**CITY OF TEMPE  
DEVELOPMENT REVIEW COMMISSION**

Meeting Date: 08/11/2015

**ACTION:** Request for an Amended Planned Area Development Overlay and a Development Plan Review for a new mixed-use 14-story development for **1000 EAST APACHE**, located at 1000 East Apache Boulevard. The applicant is Snell & Wilmer LLC.

**BACKGROUND INFORMATION:** **1000 EAST APACHE (PL150208)** is proposed a 14-story (plus rooftop amenity deck) mixed-use development containing 384 dwelling units, 3,838 square feet of commercial space, and 195 square feet of restaurant space. The development is designed to serve the needs of university students. This site, previously named The Retreat at 1000 Apache, received approval in 2008 for two five-story, 67' high mixed-use buildings containing student housing, retail/restaurant, and a parking garage. An administrative amendment to the PAD was approved in 2009 to adjust the number of provided parking spaces and allow small reductions in the side and rear building setbacks. A second PAD amendment was approved by the City Council in 2013 which increase the number of dwelling units, increased the building height to 14 stories (170'), and decrease the landscape cov

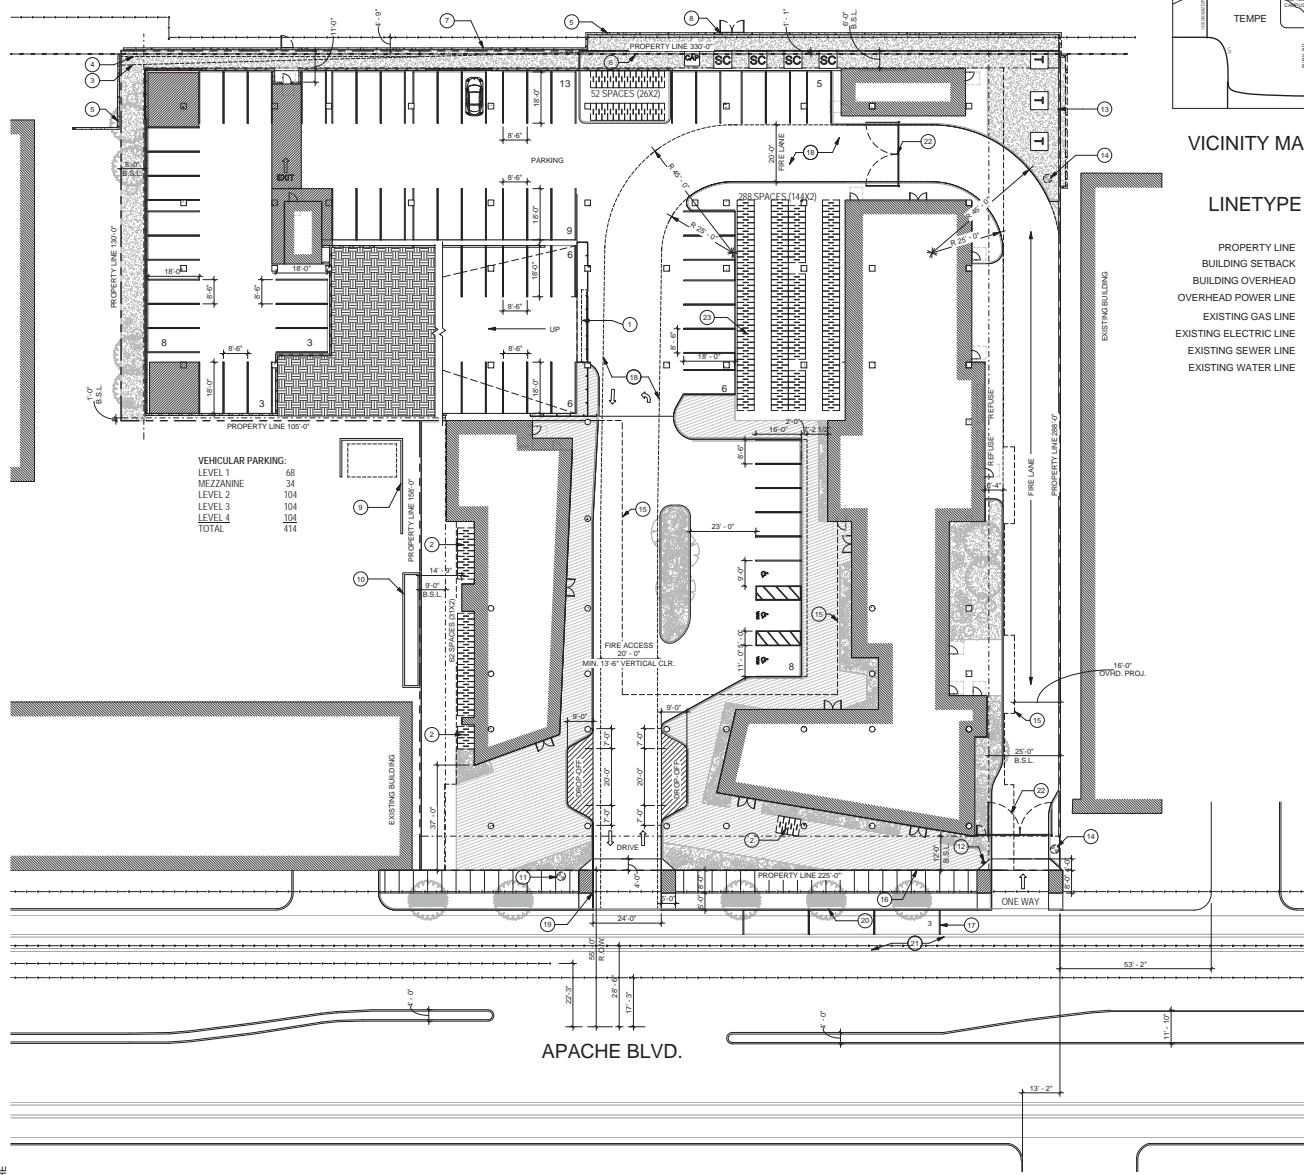
A condition is included to modify the vehicle and bicycle parking areas on the east side of the drive aisle to allow greater separation between the vehicle overhang and bike spaces directly to the east. Another condition corrects the number of bicycle spaces identified on the plan (to comply with minimum space dimensions) and requires that additional bike spaces be located interior to the building to meet the minimum number required by code.

6. To increase the clearance between the vehicle parking spaces adjacent to the 288-space bicycle parking area, reduce 1) the length of the vehicle parking spaces from 18' to 16' (with two-foot overhang) and 2) the width of the walkways between the rows of bicycle parking from six feet to five feet. These modifications will create a two and one-half foot clearance between vehicle overhangs and the west row of bicycle parking spaces.

7. The site plan shall be modified to note a total of 204 at-grade bicycle parking spaces that comply with standard detail T-578. The additional 190 bicycle spaces shall be provided and identified within dwelling units or elsewhere interior to the building.

**LANDSCAPE PLANTING PLAN**  
SCALE 1" = 20'-0"

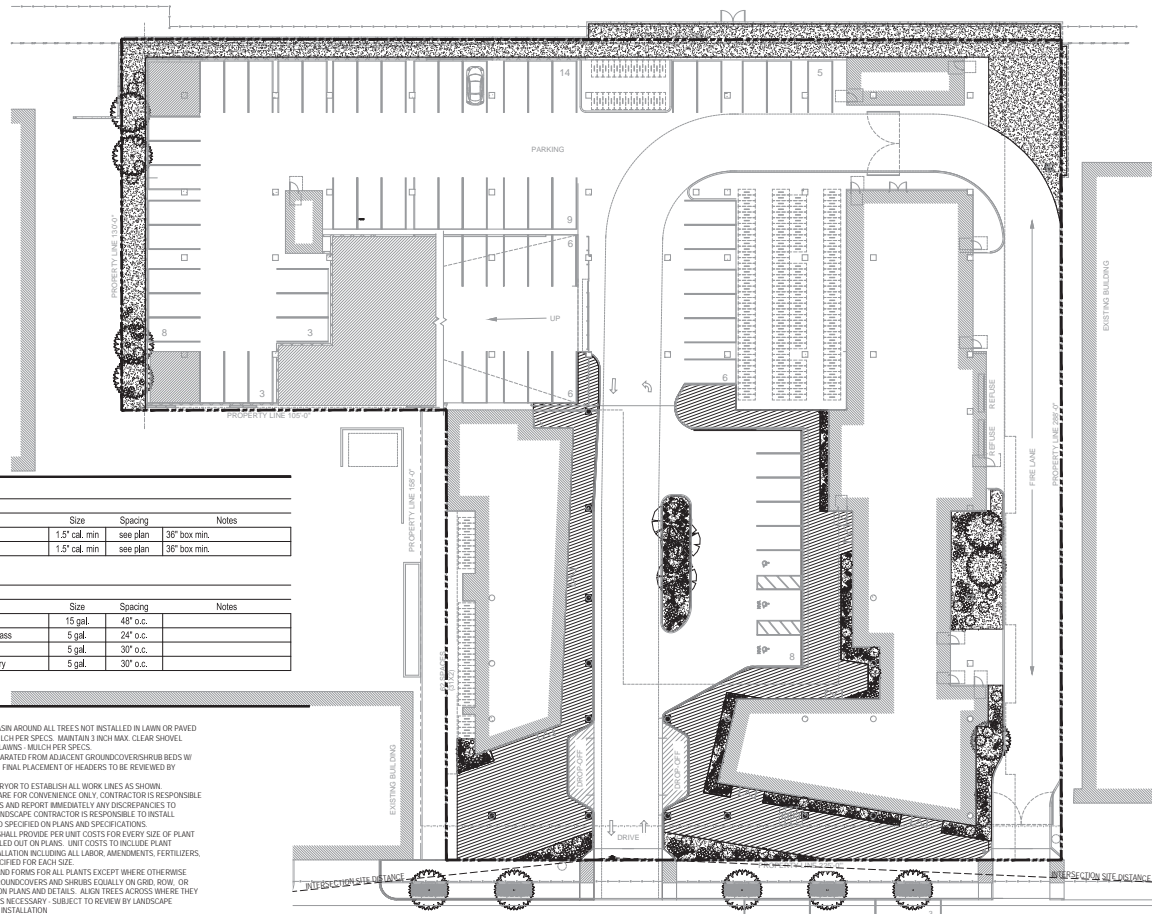
30. Trees on Apache shall be single trunk Desert Museum Hybrid Palo Verde (planted with a minimum 36" boxsize).
31. Provide street trees within 4' x 12' wide cast iron grate.

32. Increase the number of Palo Verde trees on the east side of the driveway from three to four.
33. Replace the three Ironwood trees in the parking lot landscape island with two Chilean Mesquite trees.
